LATHAN
ARCHITECTS
LATHAN ■ BRYANT ■ CALMA

ADDENDUM NO. 2
ADDITION AND RENOVATION FOR FLOMATON ELEMENTARY SCHOOL
PACKAGE A: MEDIA CENTER AND CLASSROOM ADDITION
DCM NO. 2021011 PSCA NO. 9167
Architect Job No. 21-04A
March 29, 2022

The Plans and Specifications are hereby amended. The following supersedes all contrary and/or conflicting information and is made part of the contract documents.

2 MECHANICAL ATTIC PLAN

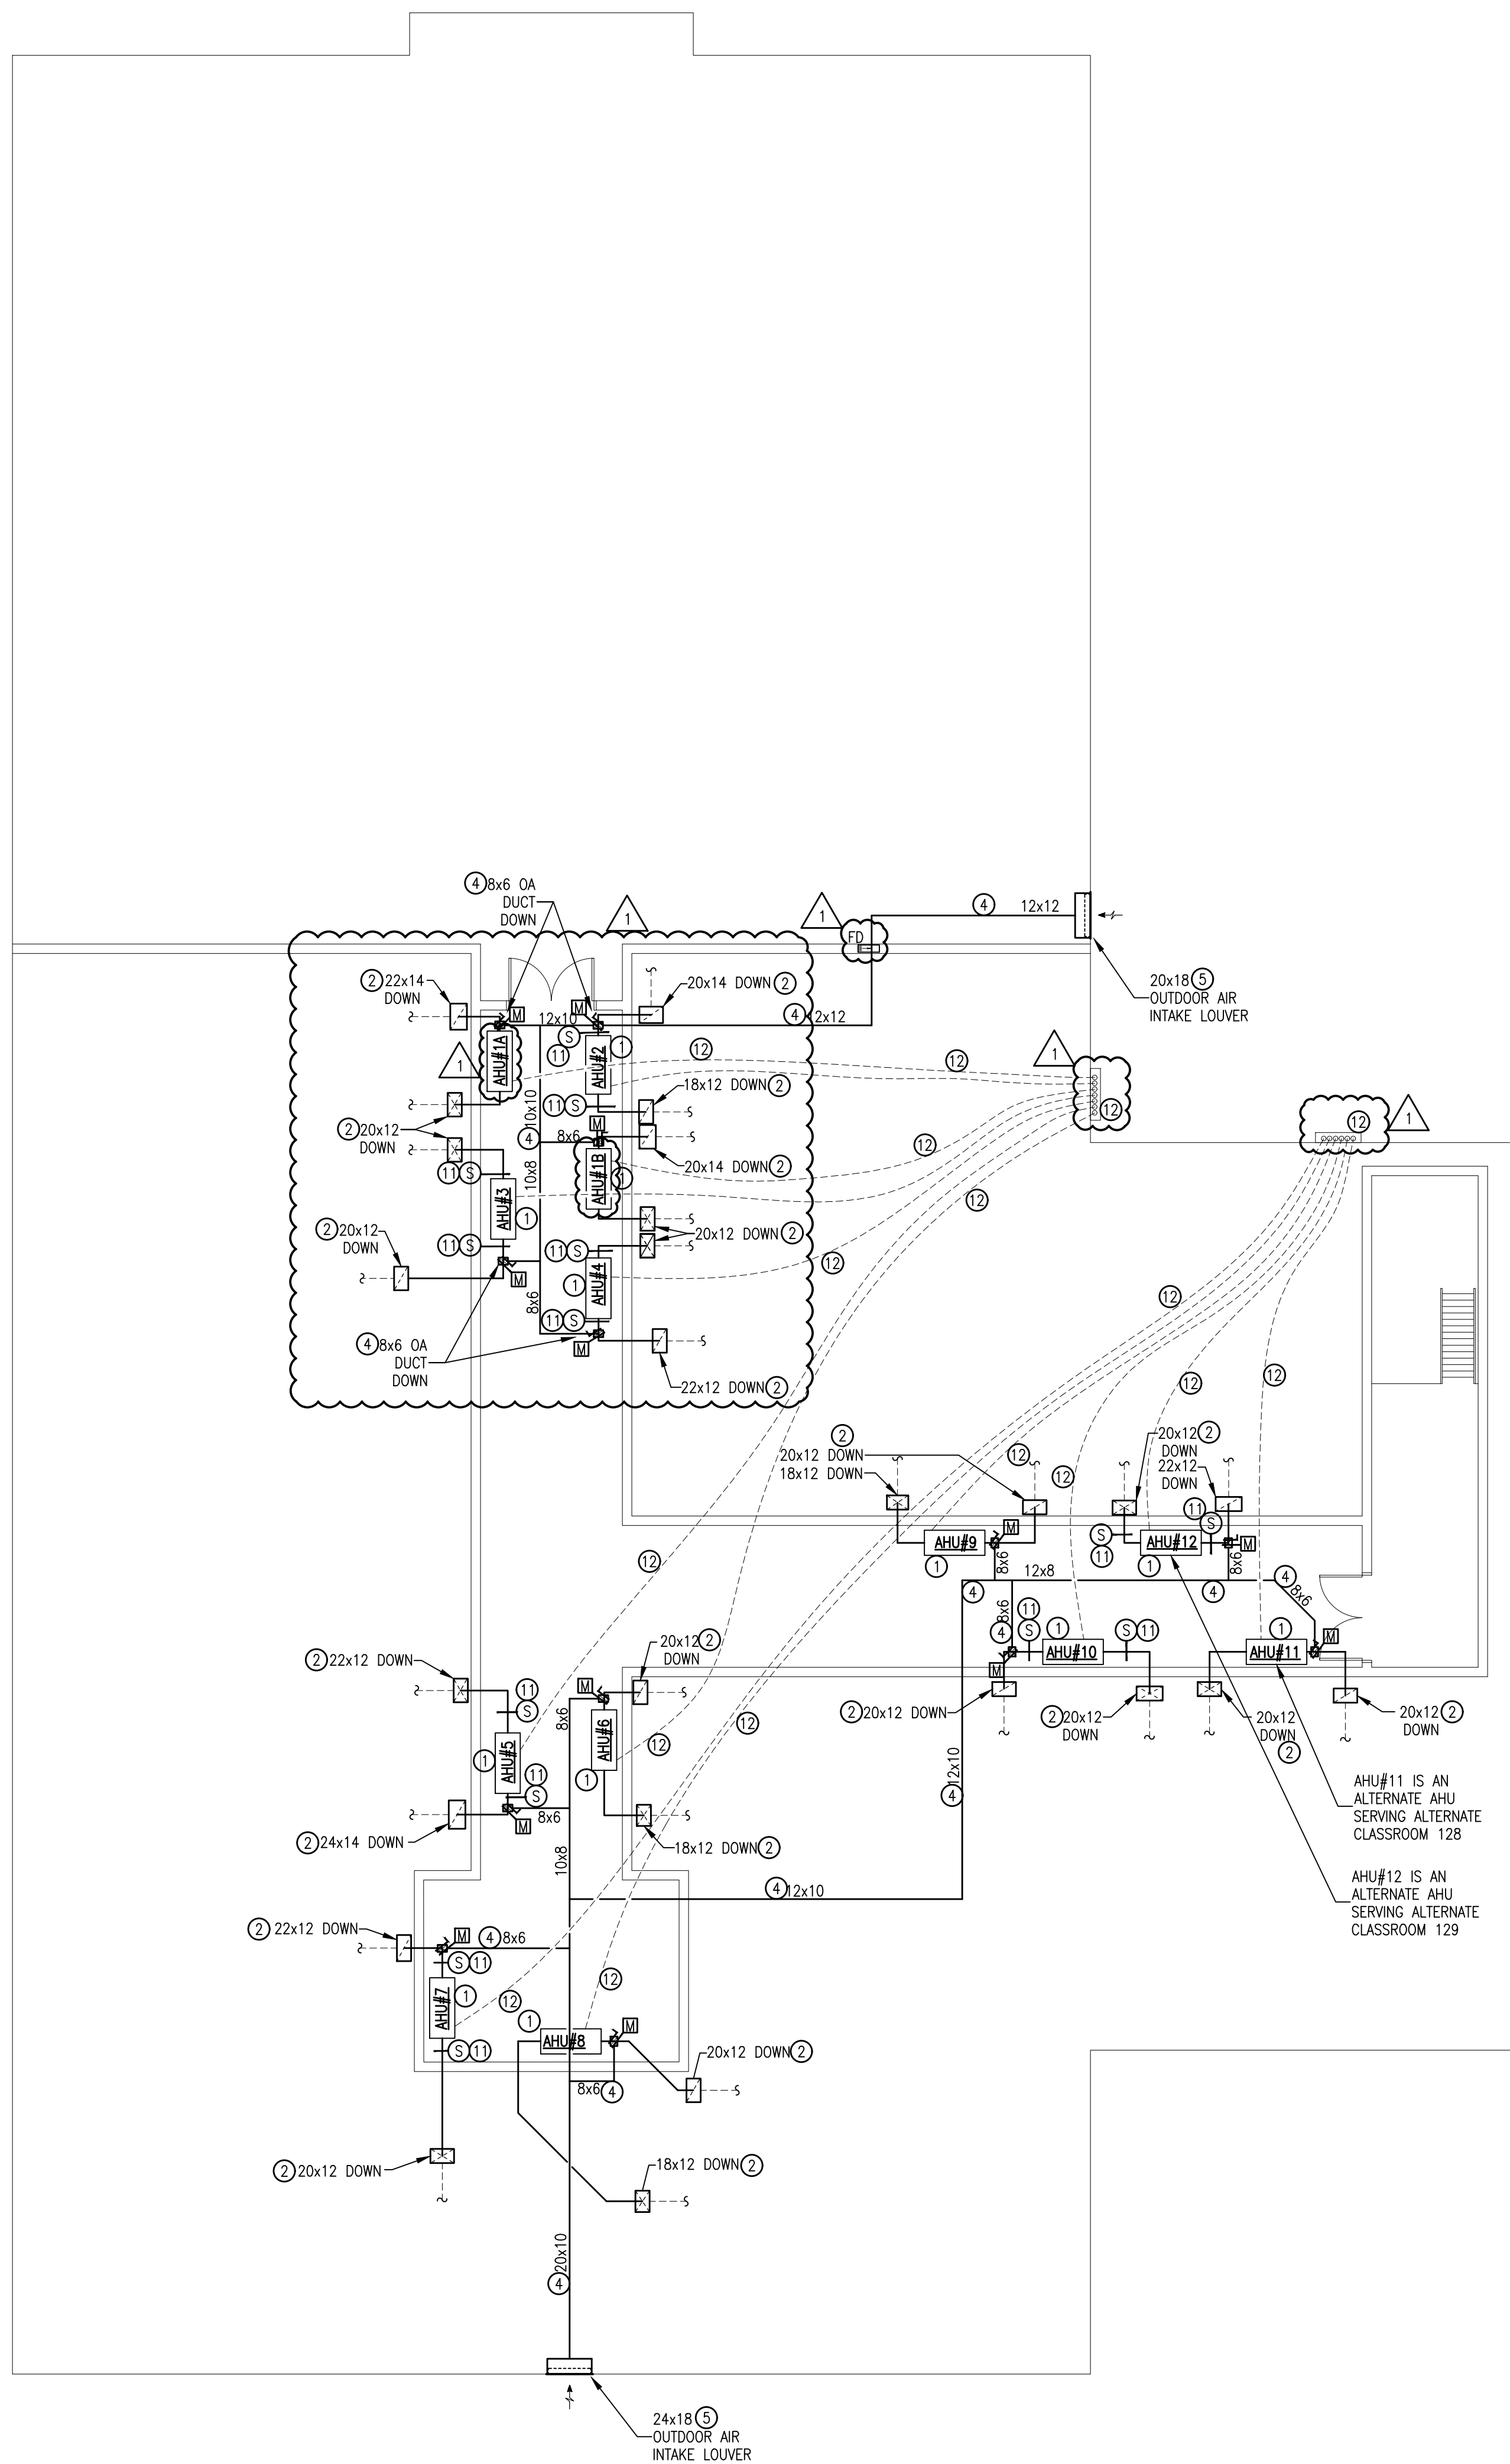
2. M1.2 – Mechanical Attic Plan – revised AHU#1 into two units, showed routing of refrigerant lines from outdoor to indoor equipment, and routing of ductwork and air handling equipment has been clarified.
3. M2.1 – Mechanical legend schedules and details - revised AHU#1 into two units.

9. Air Handling Unit #1 (AHU#1) as shown on M1.2 shall be deleted with associated ductwork. Replacement of this air conditioning unit shall be with two separate 4.0 fan air conditioning units. Duct systems shall be provided for each unit similar to those of classrooms. Electrical power requirements of the two new units shall be similar to classroom units.

1 ELECTRICAL SITE PLAN

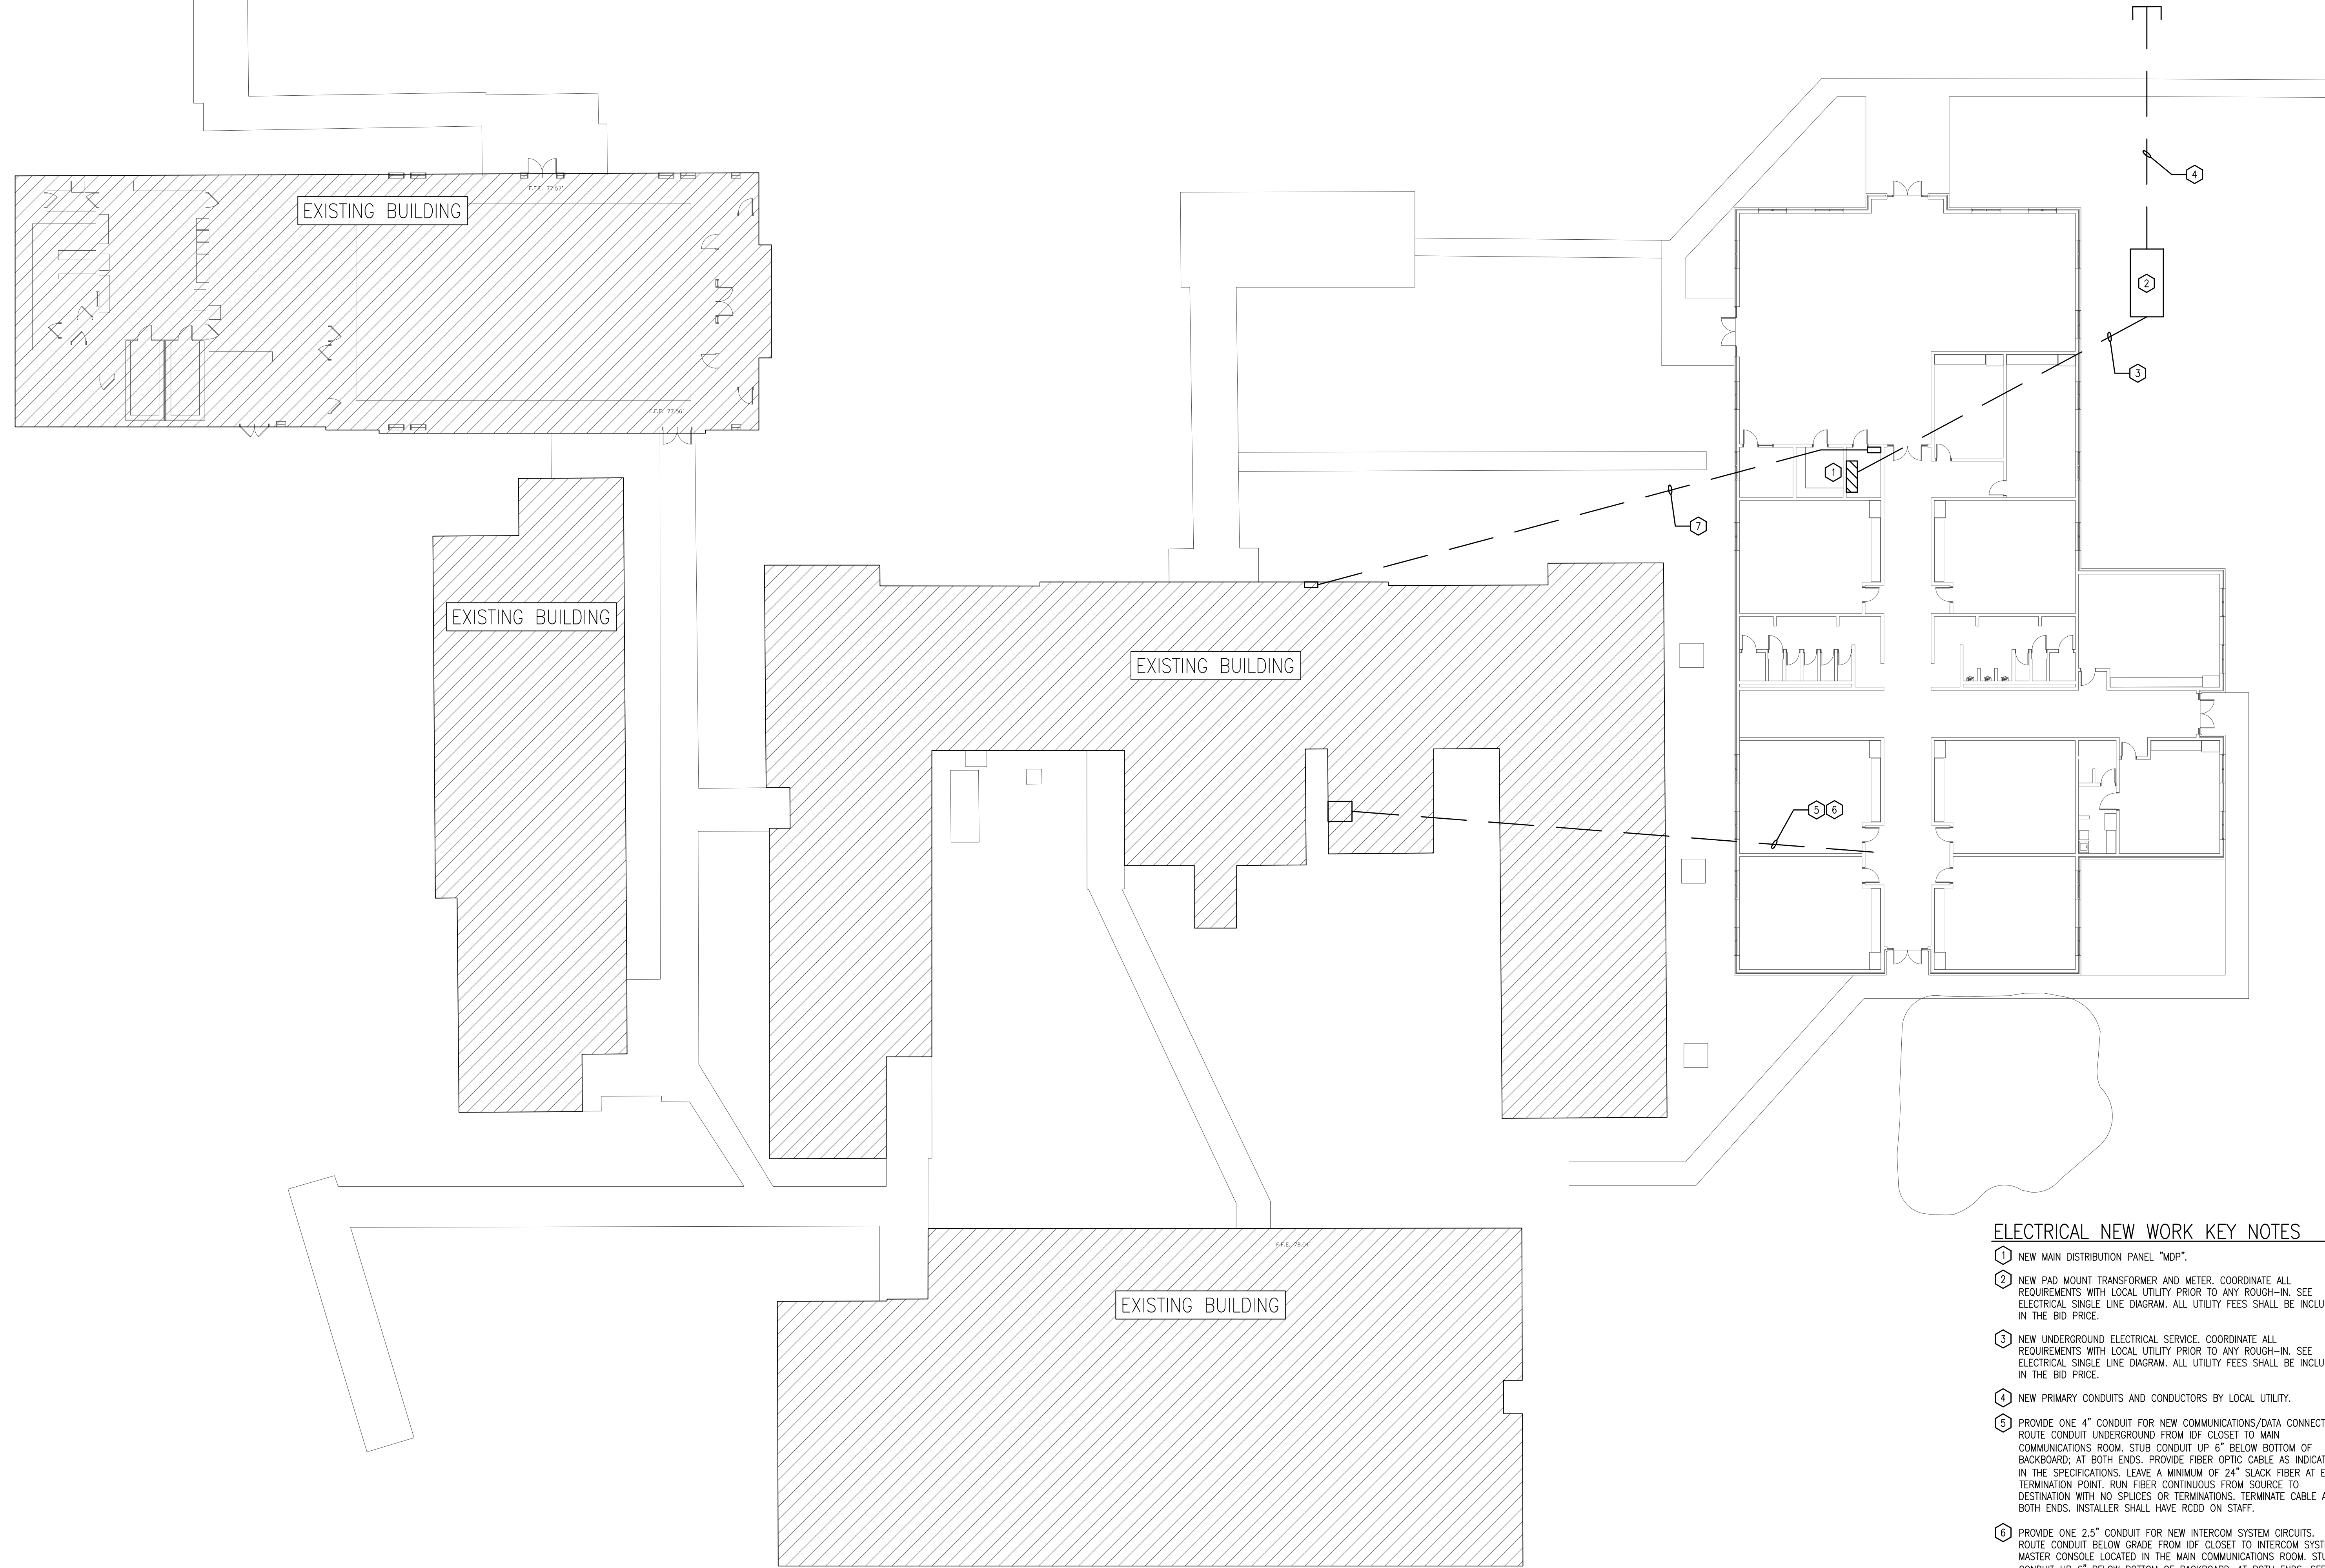
2. E0.1 – Electrical Site Plan - revised electrical site plan.
3. E1.1 – Lighting and Power Plan – Revised sheet to include additional exit signs have been added and the locations have been coordinated with the architect, Circuits have been revised such that they are being fed from the existing building, WSEM has been added to the emergency lighting schedule, and dimmer switches have been added to all offices and classrooms to allow bi-level control.
